Applies To: **1997 – 98 Prelude – ALL**
1999 Prelude – thru VIN JHMBB6...XC010811

July 20, 1999

Door Is Difficult to Open From the Inside (Supersedes 97-052, dated August 27, 1997)

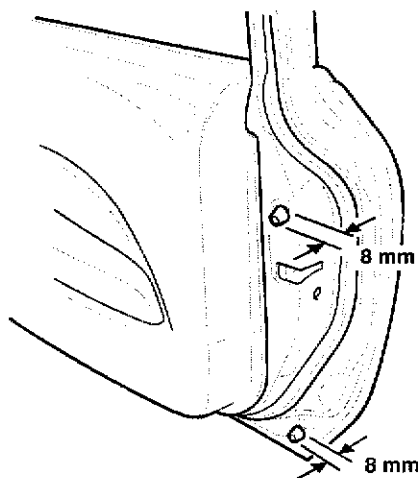
1. Remove the door panel. Refer to page 20-4 of the 1997 - 99 Prelude Service Manual.
2. Remove the plastic rain protector by cutting the adhesive with a razor blade.
3. Disconnect the inner handle rod from the rod crank and the latch assembly. Remove the rod from the door.

4. Install the new inner handle rod to the latch assembly and the rod crank.
5. Reinstall the plastic rain protector.
6. Reinstall the door panel.
7. Adjust both door cushions to 8 mm.

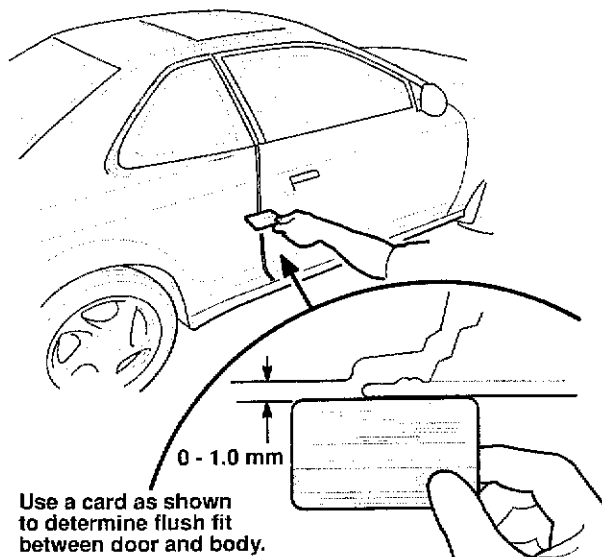
8. Use a credit card or driver's license to inspect the fit at the rear of both doors. The door edge should be flush with the body to 1.0 mm away from the body.

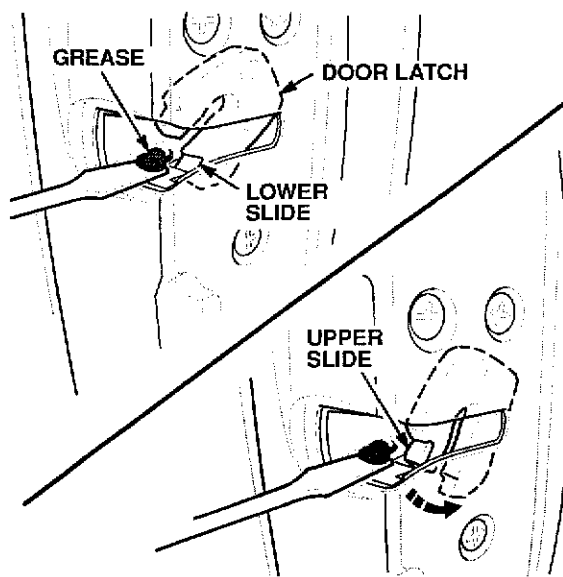
9. If the door edge is recessed or if there is a gap of more than 1.0 mm, adjust the striker.
10. Clean the latch with shop air to remove any dirt.
11. Use a pocket screwdriver to apply a small amount of Lithium dielectric grease to the lower slide. Use the screwdriver to close the latch to the first click, then apply a small amount of grease to the upper slide.
